Paseo Community Development District

**Board of Supervisors' Meeting
July 22, 2020**

ANNUAL REVIEW OF DISTRICT ASSETS

July 9, 2020

Picture 3 (P3)

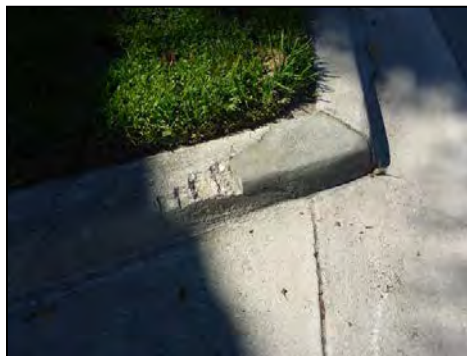
Moderate fracture in type "F" curb with missing concrete.

Replace section of curb.

Picture 5 (P5)

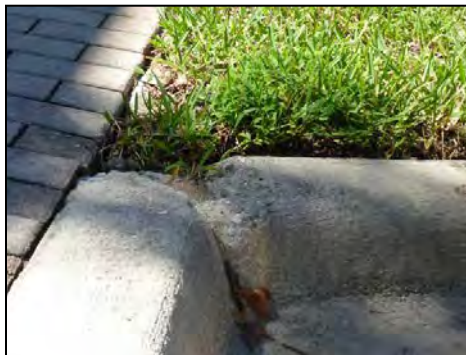
Type "F" curb with missing piece.

Repair missing curb.

Picture 9 (P9)

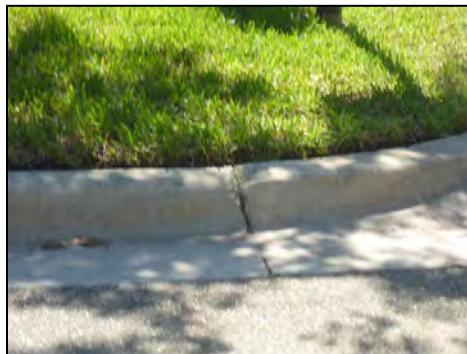
Street sign is faded and peeling.

Replace street sign.

Picture 59 (P59)

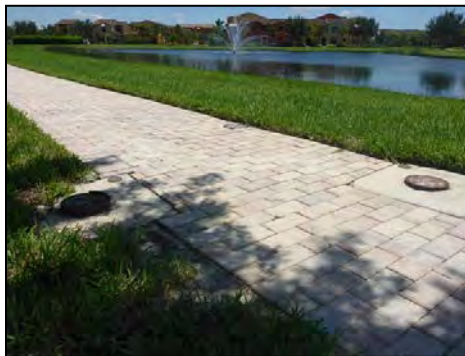
Water valve ring and cover protruding from concrete base.

Notify City of Fort Myers Utilities department.

Picture 106 (P106)

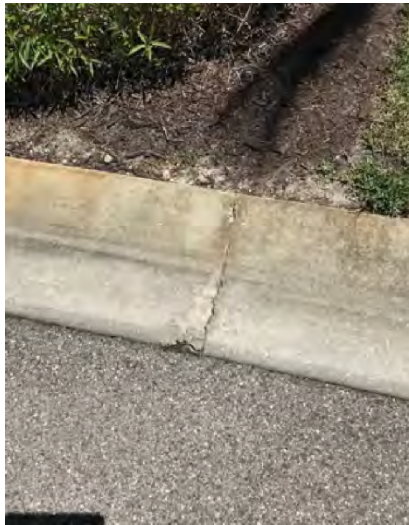
Multiple moderate fractures in valley gutter curb.

Replace portion of curb.

Picture 141 (P141)

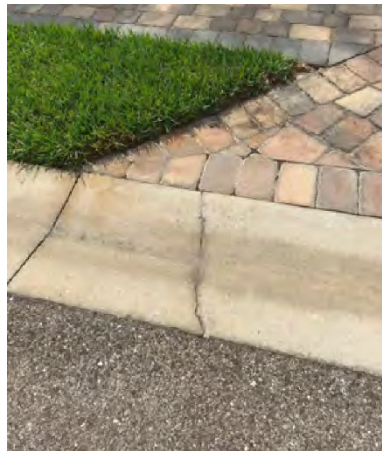
Moderate fracture in valley gutter curb.

Replace portion of curb.

Picture 163 (P163)

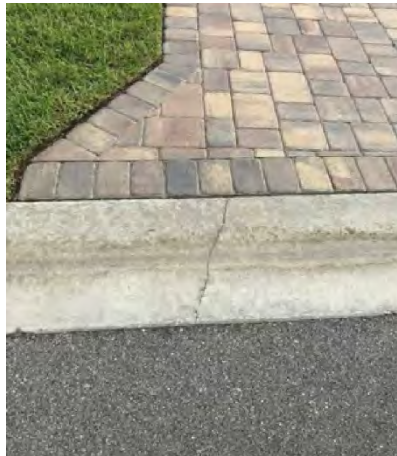
Fire hydrant is obstructed by landscaping.
